ITEM 0.0 PROPONENT INITIATED PLANNING PROPOSAL - 171-179 GREAT NORTH ROAD & 1A-1B HENRY STREET, FIVE DOCK**Reporting Manager Strategic Planning**

To seek advice from the Local Planning Panel (LPP) regarding a Planning Proposal relating to 171-179 Great North Road & 1A-1B Henry Street, Five Dock.

Figure 15: Recommended maximum building heights

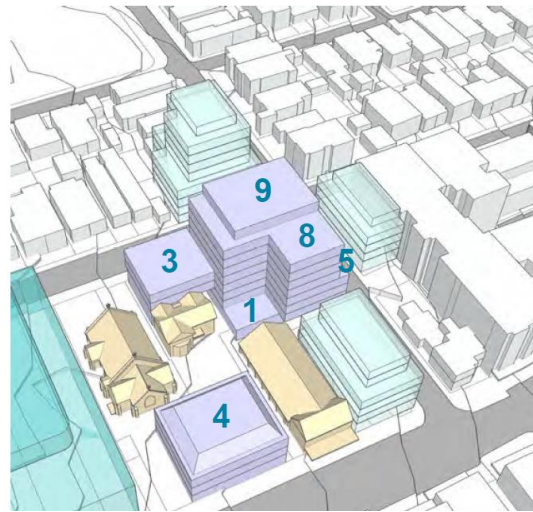
Whilst the location of the Metro Station adjacent to the site represents an opportunity for increased development, it is not justification for the 75m maximum height proposed. The scale of the proposed 75m towers is out of context with the existing and desired mid-rise character of the Five Dock Town Centre (and with the heights proposed in the EIE for low- and mid-rise housing). If the forecast heights are compared with the illustrated heights in the Planning Proposal, it is apparent that the proposed towers will be out of context within the future town centre.

- a) The maximum Floor Space Ratio be retained at 2.5:1.
 - b) The maximum Height of Buildings be reduced, consistent with the draft Height of Buildings Map, provided at Attachment 2.

Figure 17: Recommended Height of Buildings Map
(Council mapping system)

Figure 18: Planning Proposal – Proposed built form

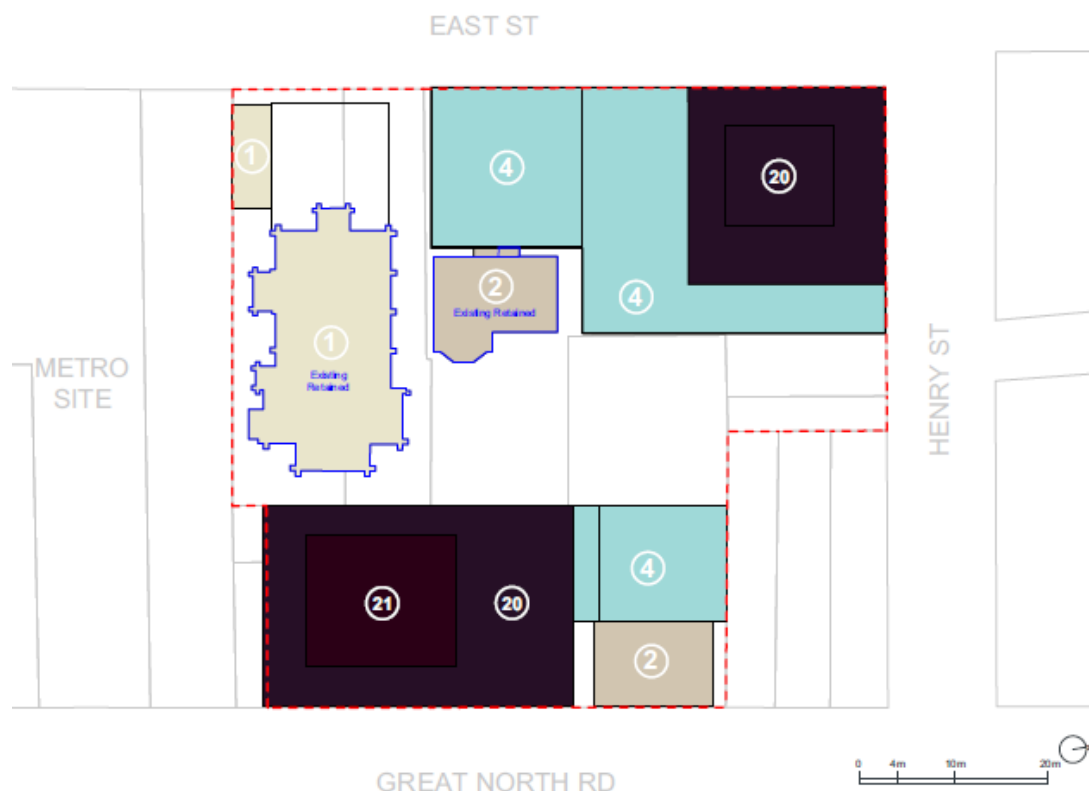
The Planning Proposal request to amend the maximum FSR standard from 2.5:1 to 4.5:1 is not supported.

The existing site FSR of 2.5:1, applies to most properties along Great North Road, and assumes development can be built boundary to boundary, reflective of a main retail street in a town centre. The retention of heritage building on the site, combined with the recommended built form up to 9 storeys achieves an FSR of approximately 1.73:1. Whilst, this FSR is lower than the current FSR, this outcome is expected given the constraints associated with low the scale heritage buildings on the site and limits on development before the overshadowing Fred Kelly Place.

Retaining the existing maximum FSR of 2.5:1 is therefore recommended.

Figure 19: Recommended built form

Figure 20: Level 4-podium (Urban Design Report)

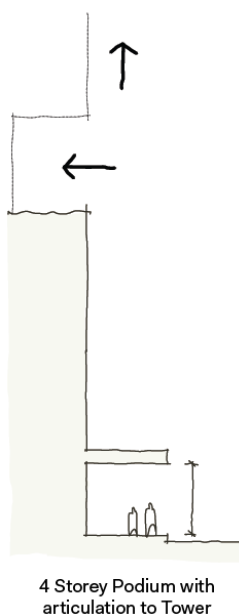
While the proposed podium is no taller than the transept of the church, the single level setback of the fifth storey, where the upper levels (storey 6 to storey 20) are cantilevered and built to the podium edge, means that the bulk and scale of the building dominates the heritage context.

Figure 22: Interior view and Shops of St Alban's Anglican Church Hall

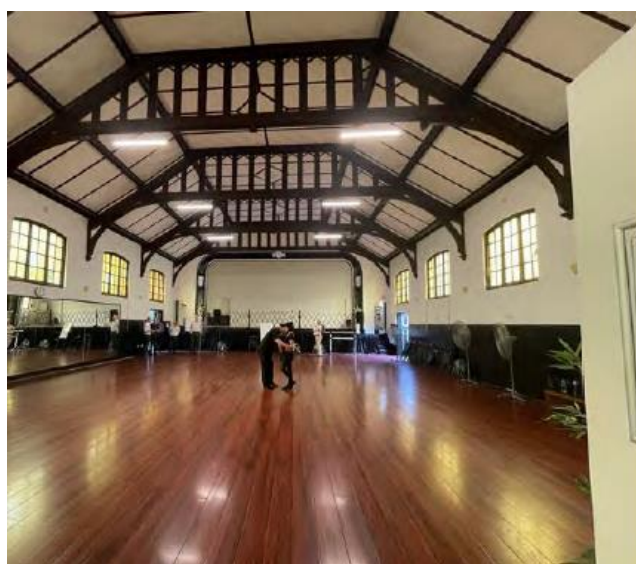
Demolition of the hall will result in the loss of a very unusual, rare and intact heritage item. This is a significant inconsistency with the Direction that has not been adequately justified.

The alternative scheme enables the Hall and Shops to be retained and the 'service wing' at the rear may to be removed. The Hall and Shops remain detached and separated from any potential new development to the south, to enable the views of the Hall from Great North Road to be retained.

Figure 23: Terminating view from Second Avenue (looking west) with the Planning Proposal built form.

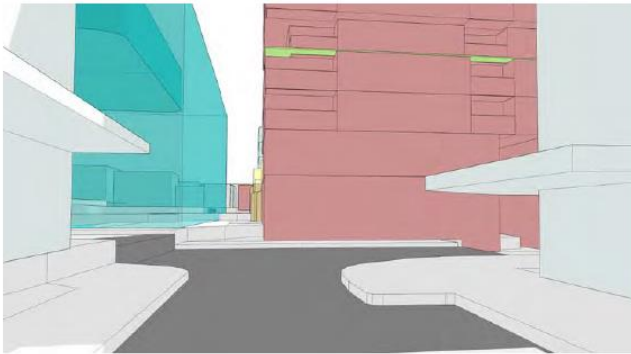
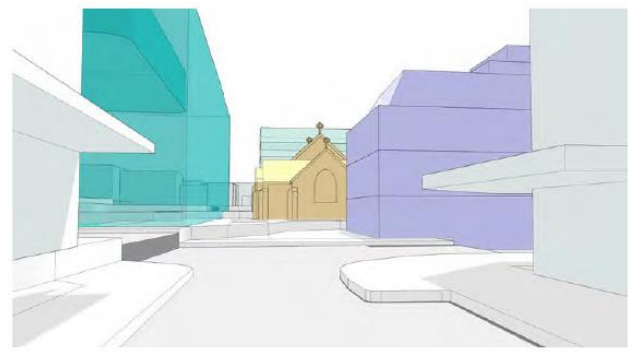
From Second Avenue, the podium is unsuccessful in reducing the perceived bulk and scale of the proposed tower fronting Great North Road. The existing view that frames the heritage listed Church and features green landscaping would be replaced by a large 20 storey tower that dominates the streetscape and blocks views of the Church.

It is recommended that the terminating view of the Church from Second Avenue (looking west) is retained so as to see, at a minimum, the heritage building between the southern boundary and the highest cross on the Church roof. An 8.0m setback from the southern site boundary to development that fronts Great North Road, with a roof form for the fourth storey will achieve this outcome.

Figure 27: Proposed shadows in Fred Kelly Place

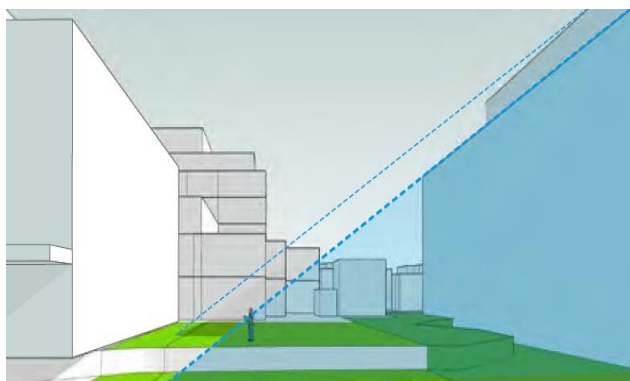
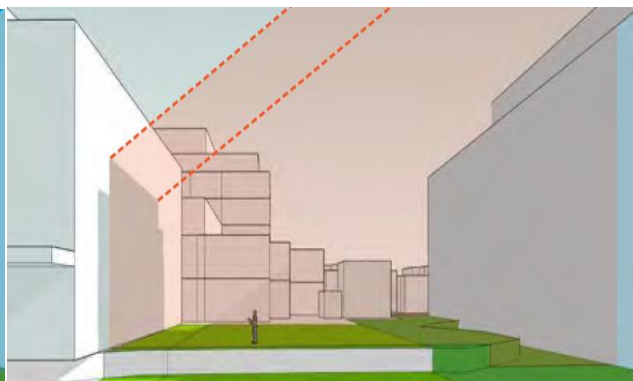
The proposed 75m heights of the 2 towers, which could potentially increase to 97.5m under Clause 18 of the Housing SEPP, will result in overshadowing of Great North Road, the surrounding local streets and the proposed new Town Square, which will comprise a wider Fred Kelly Place and future Plaza on the eastern side of Great North Road.

The alternative floor space ratio, building height and building envelope will enable a satisfactory level of solar access to surrounding open space and properties.

Figure 28: Proposed Basement and deep soil (Landscape Report)

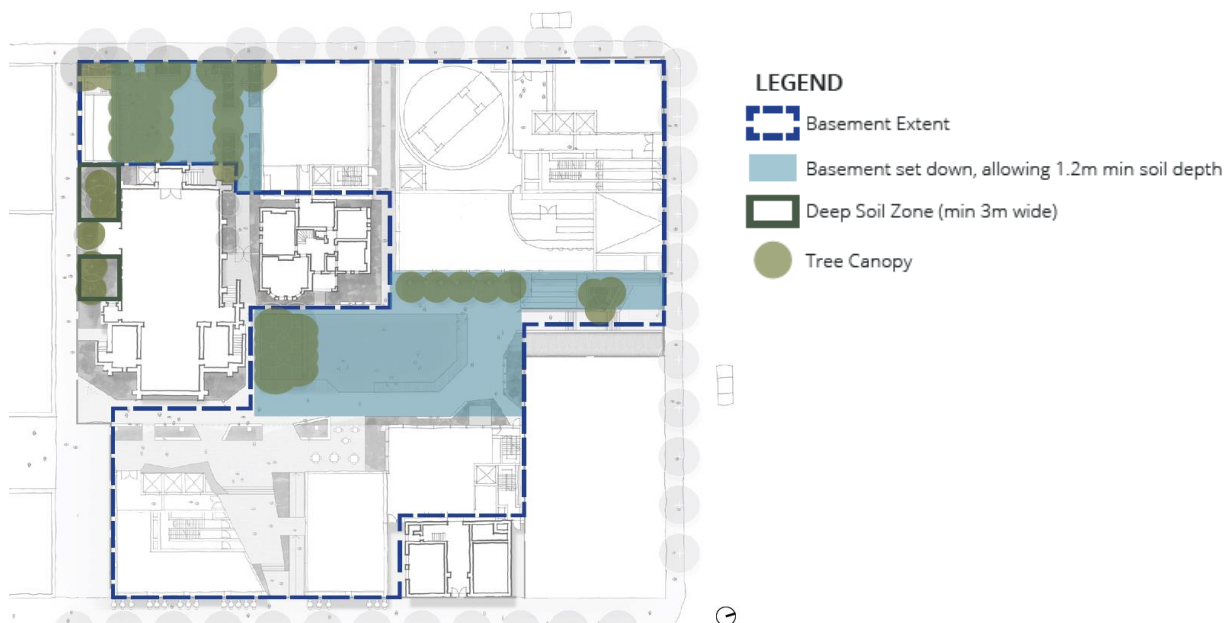
The Planning Proposal has reduced the amount of deep soil on the site from approximately 30% to approximately 1% and reduced tree canopy coverage on the site from approximately 17% to approximately 10%. Most of the proposed trees are located over basement car parking and the trees shown in front of the entry to the Church off East Street are proposed to be located within a 'Covered Space'.

The Reference Scheme's outcome of 1% deep soil zone and 10% tree canopy coverage on the site is insufficient. The alternative scheme will enable approximately 10% deep soil to be provided on the site.

Figure 29: Proposed through-site links.

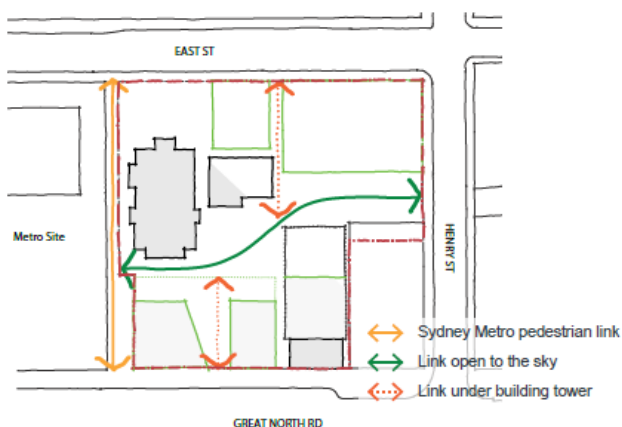
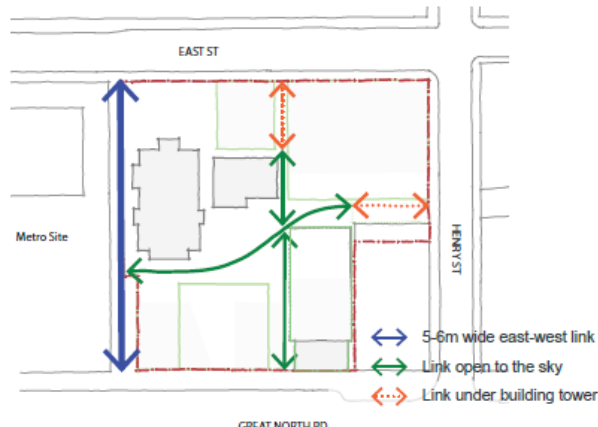
Three pedestrian links are proposed within the site boundary, none of which provide a direct line of sight from one end to the other. This significantly restricts visual permeability and impacts safety and security for pedestrians.

It is recommended that the Planning Proposal supplement and enhance the Sydney Metro east-west link by making the space an open and uncovered landscaped setback to the Metro pedestrian link and by relocating the proposed Kitchenette and WC.

The alternative scheme includes revised through-site links to improve visual permeability by connecting the two east-west links. The revised scheme also enhances wayfinding for pedestrians by reducing the number of under-building pathways, where pedestrians are concealed.
